**MEETING OF THE
PLANNING AND ZONING BOARD
QUASI-JUDICIAL PUBLIC HEARING**

April 19, 2016

Subject: Site Development Plan Application
One Kane Concourse - Tauber Commercial / Office Building
9551 East Bay Harbor Drive
Revisions to 2011-12 Town Approval
Bay Harbor Islands Acct. No. BP2016-88
MMPA Acct. No. 01-0702-946B

**Planning and Zoning Board Staff Report
One Kane Concourse / Tauber Commercial Development
9551 East Bay Harbor Drive
Site Development Plan Application – 2015/16 Revisions
April 4th, 2016
Page 2**

1 LEVEL 2
SCALE: 1/16" = 1'-0"

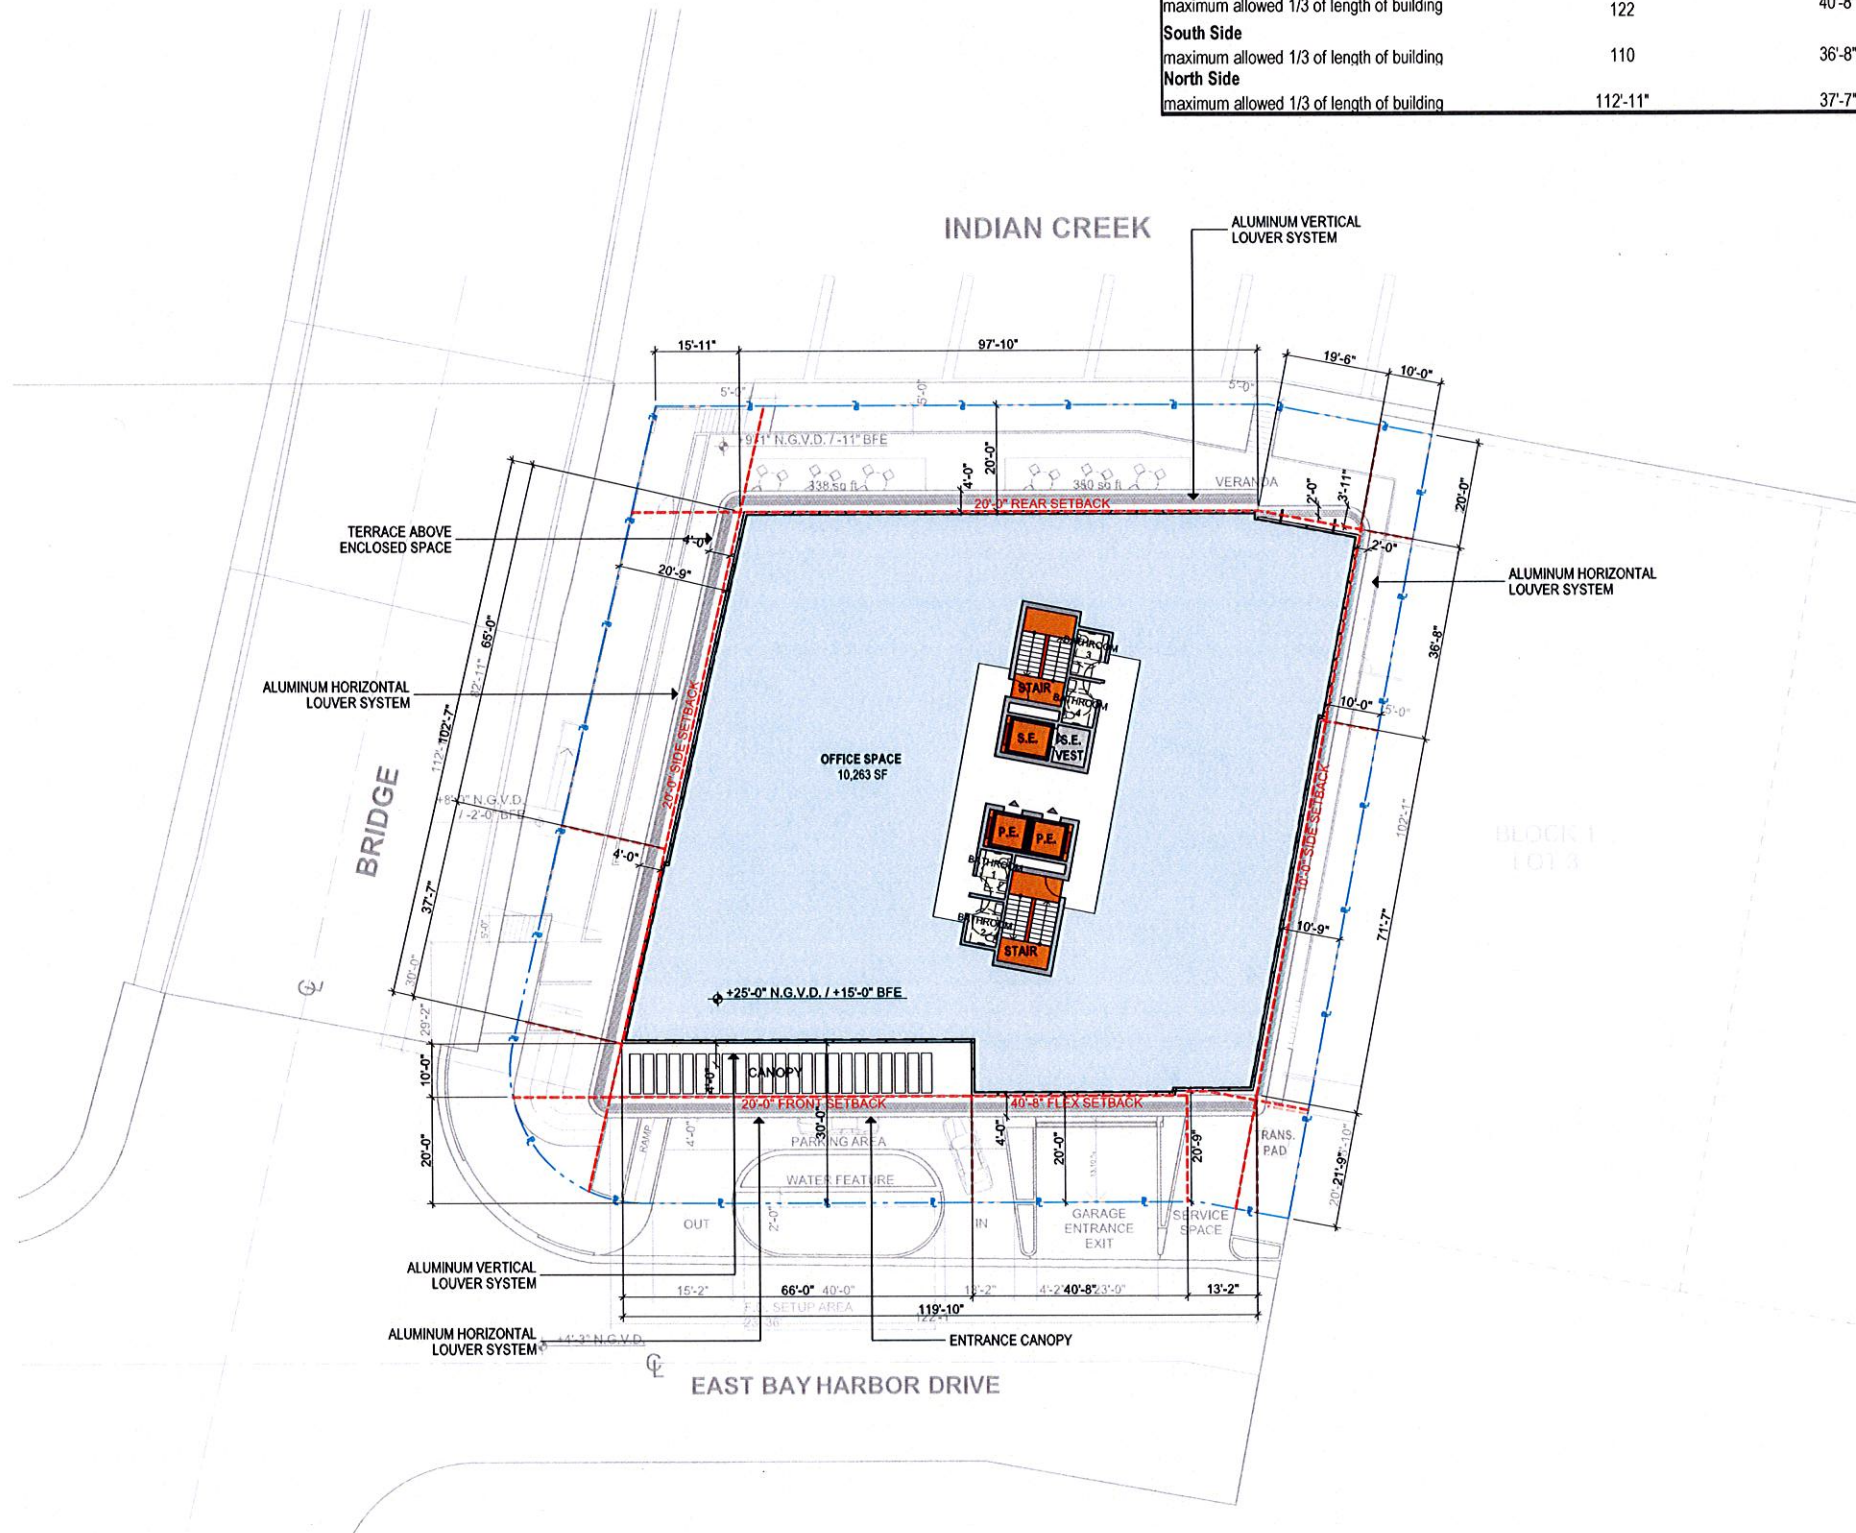
Flex Setbacks		Allowable setback (Feet)	Proposed (Feet)
West Side			
maximum allowed 1/3 of length of building	122	40'-8"	40'-8"
South Side			
maximum allowed 1/3 of length of building	110	36'-8"	36'-8"
North Side			
maximum allowed 1/3 of length of building	112'-11"	37'-7"	37'-7"

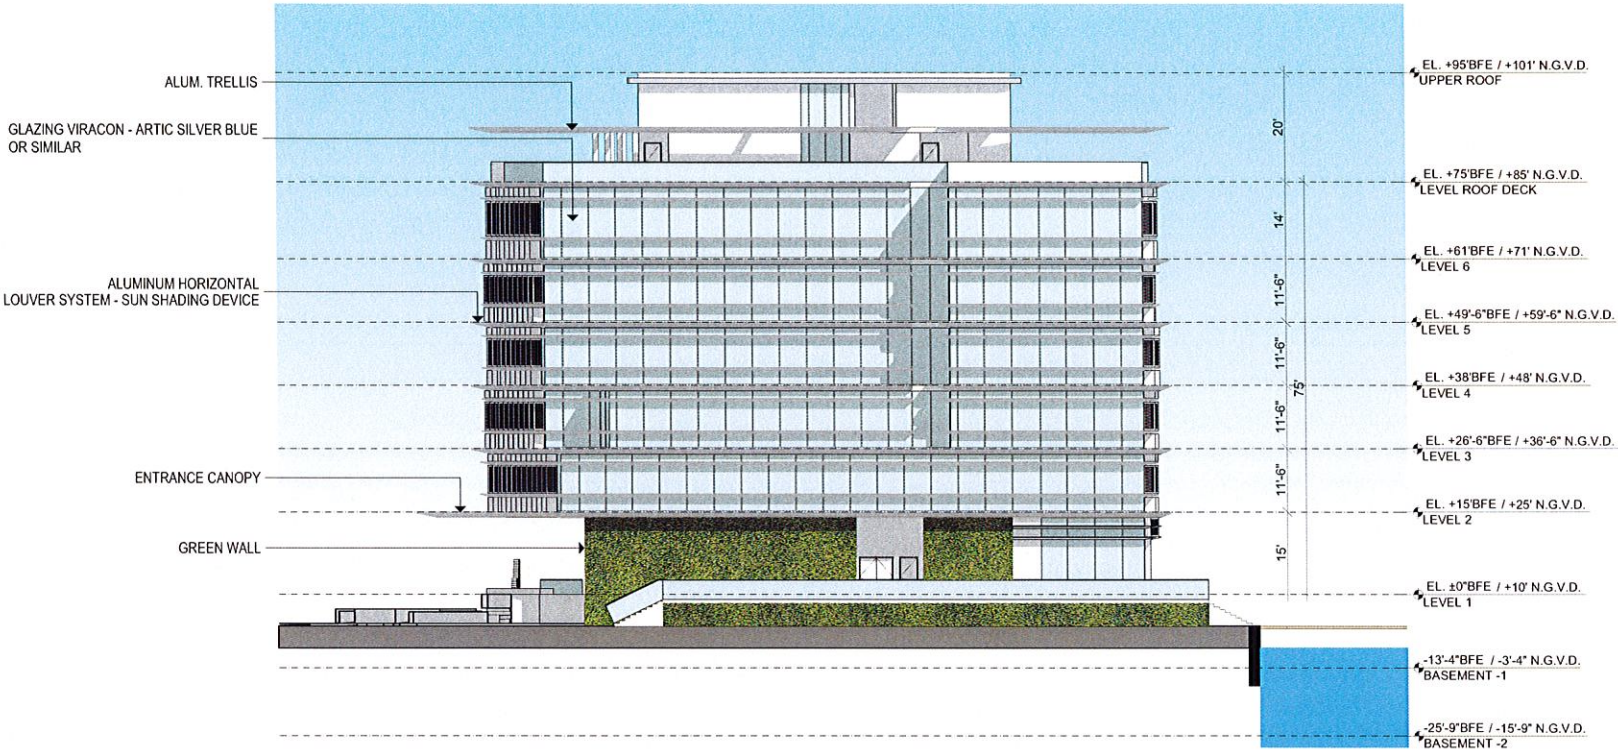
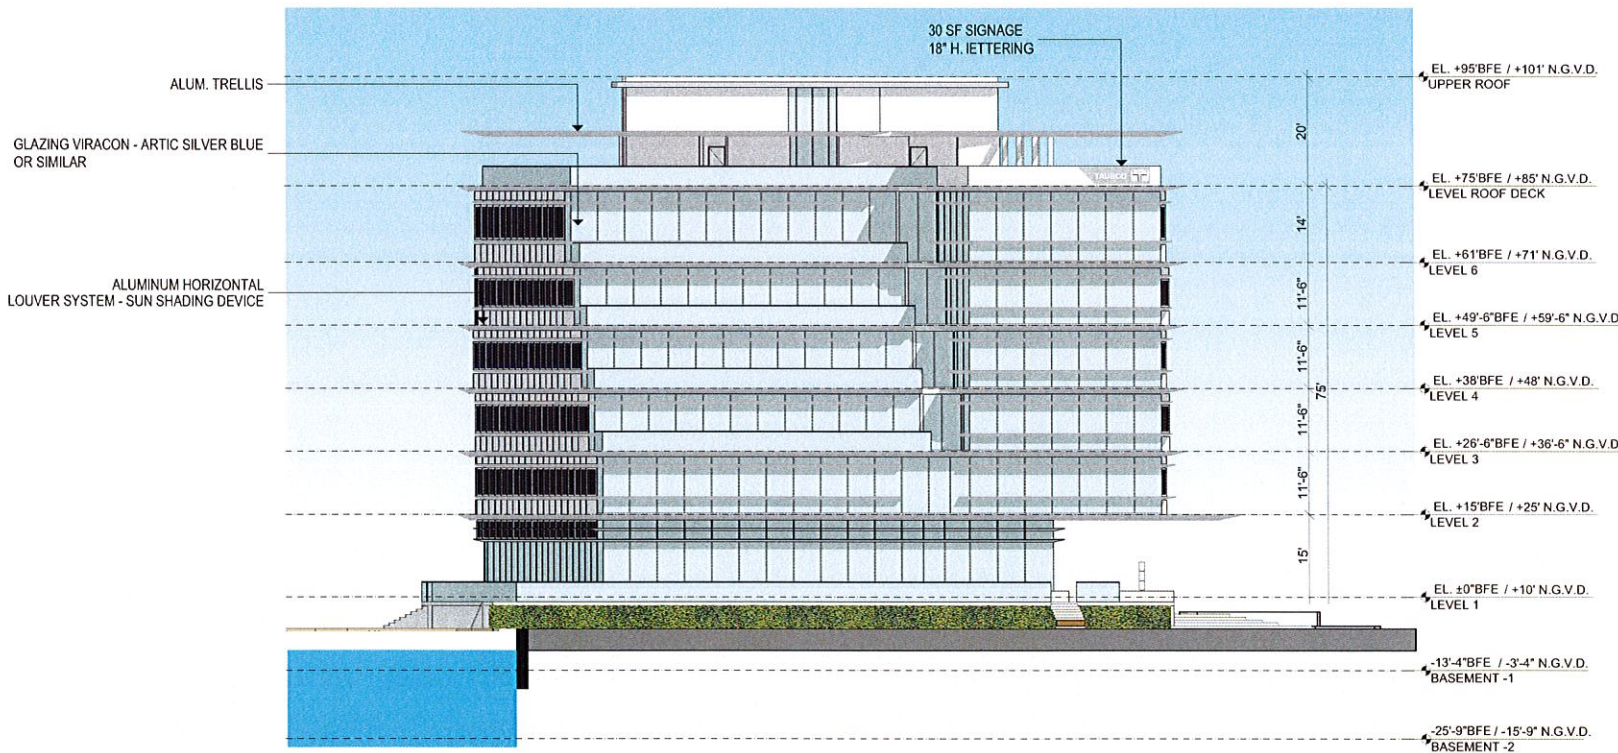
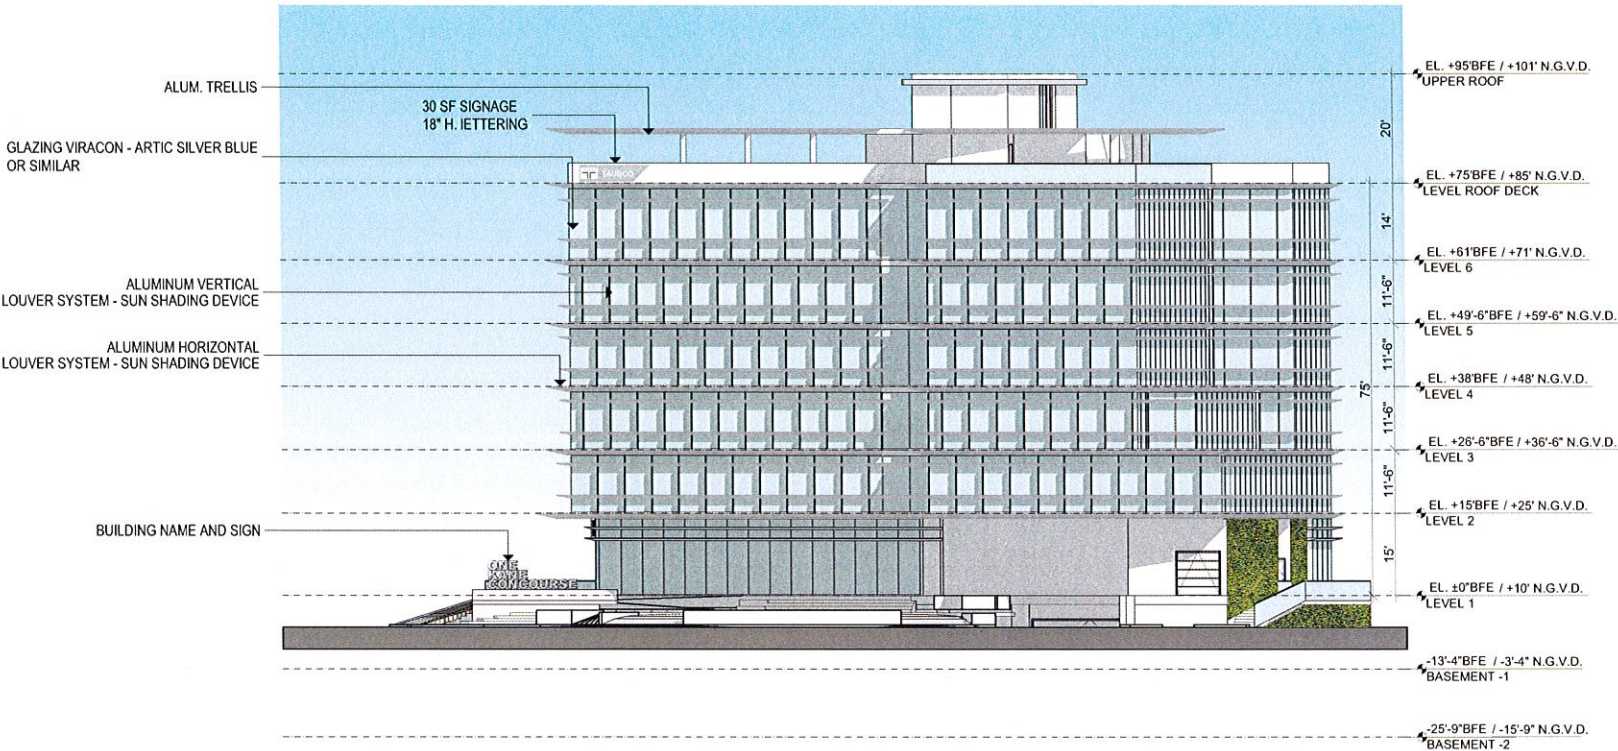
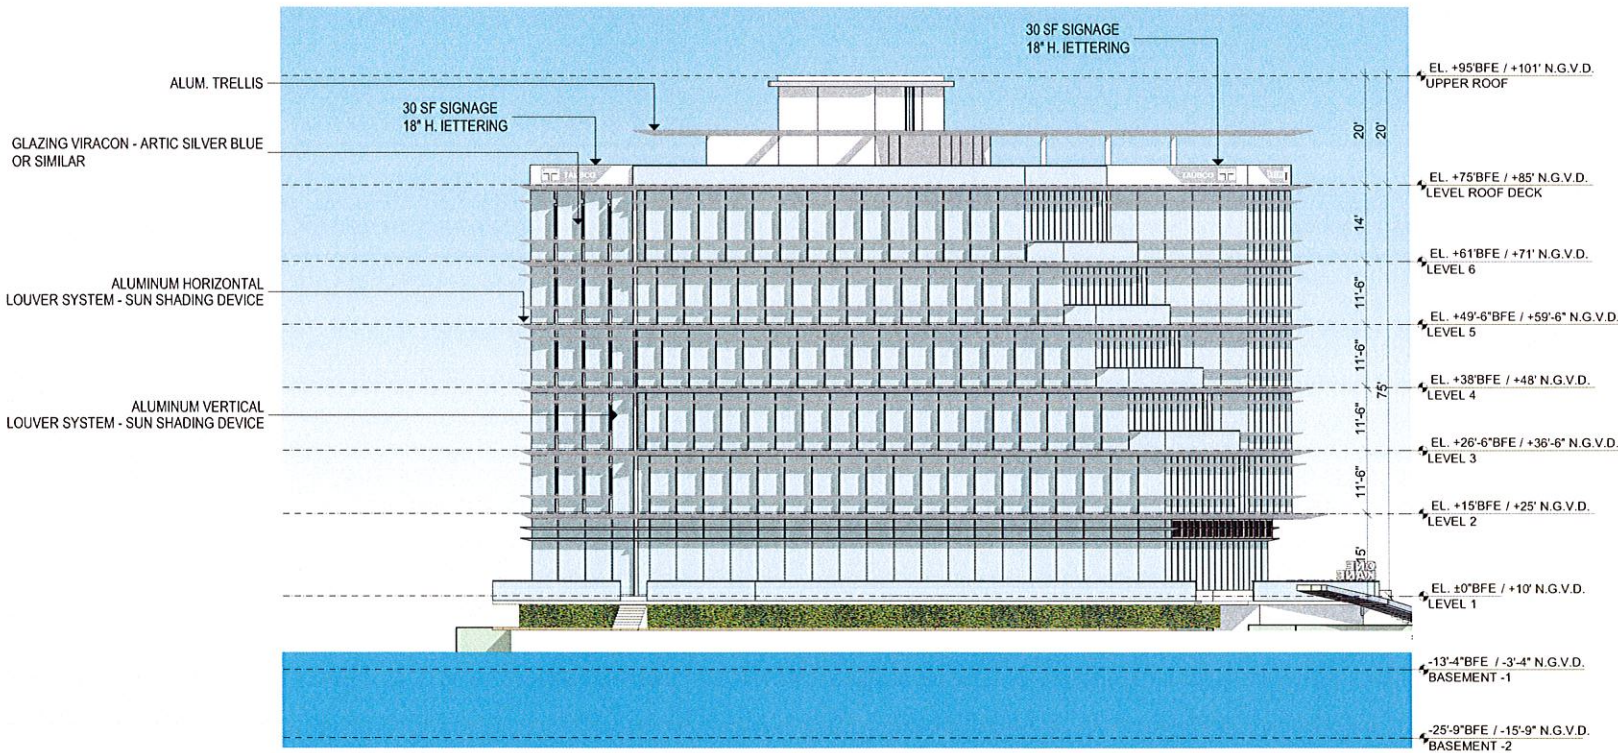
The building elevations are significantly different than the 2011-12 approved plans. For example, the new “flex” building massing facing Kane Concourse is proposed near the roadway intersection versus the waterfront. This changes the bulk massing appearance from Kane Concourse. The new architectural design has numerous vertical components on the building façade presenting a “busier” appearance, while the previous plan had long horizontal elements with few vertical architectural breaks giving a “softer” appearance. Also the accessory rooftop structures (elevator shafts / stairs / bathrooms / mechanical rooms) are much larger / taller than the currently approved design. These modified building design features should be considered carefully by the PZB / TC. The Town Code states the Town “**may**” approve flex building features if deemed acceptable (not mandatory).

- 3) MMPA notes that the building elevations are significantly different than the 2011-12 approved plans. For example, the new “flex” building massing facing Kane Concourse is proposed near the roadway intersection versus the waterfront. This changes the building massing appearance along Kane Concourse. The new architectural design has numerous vertical components on the building façade presenting a much “busier” appearance, while the previous plan had long horizontal elements with few vertical architectural breaks giving a “softer” appearance. The proposed accessory rooftop structures (elevator shafts / stairs / bathrooms / mechanical rooms) are much larger / taller than the current design. MMPA does not normally comment on architectural design features, as that is primarily the purview of the PZB / TC; however, this is a community entranceway “Gateway” site, so extra design attention is warranted. The Town Code states the Town “**may**” approve certain building design features, such as building flex areas, if deemed acceptable.

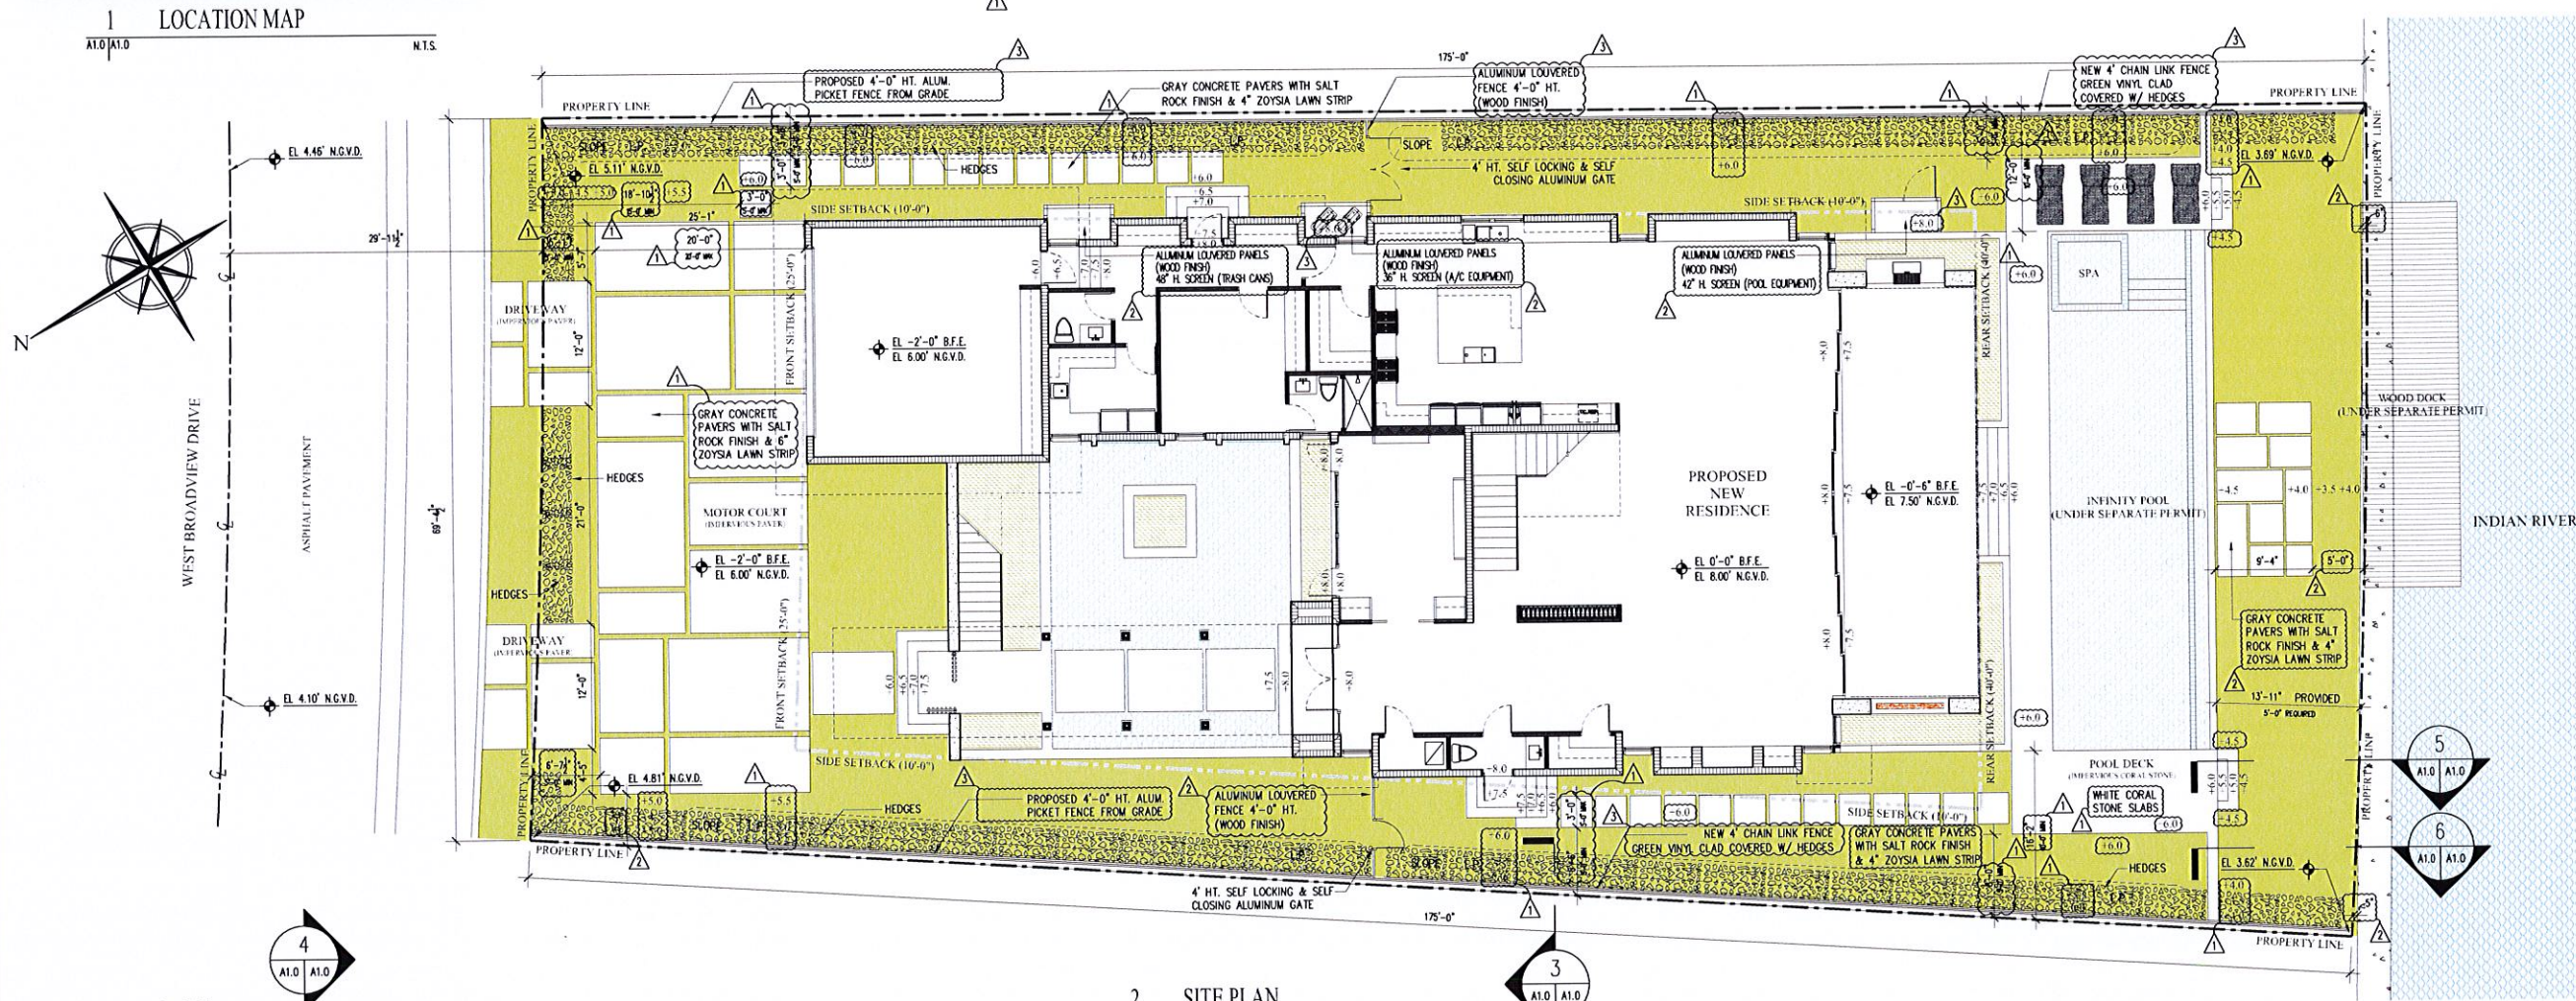
It should be noted that the finished grade in the side yards as well as a portion of the rear yard is being requested to be raised. Per Sec. 23-12(12) of the Town's Code, BFE (8.0' at this location) is the maximum height allowed. The applicant is requesting to raise portions of the lot to 6'-0", which is 2'-0" below the maximum permitted. Raising the lot will make the finished grades at the adjoining lots unequal. Section 23-12(12) states that finished grades at adjoining lots shall be equal unless the PZ Board approves a retaining wall system. Therefore, Planning and Zoning Board approval is required for the retaining wall system proposed.

- 2) The finished grade in the side yards as well as a portion of the rear yard is being requested to be raised. Per Sec. 23-12(12) of the Town's Code, BFE (8.0' at this location) is the maximum height allowed. The applicant is requesting to raise portions of the lot to 6'-0", which is 2'-0" below the maximum permitted. Raising the lot will make the finished grades at the adjoining lots unequal. Section 23-12(12) states that finished grades at adjoining lots shall be equal unless the PZ Board approves a retaining wall system. Specific Planning and Zoning Board approval is required for the retaining wall system proposed.
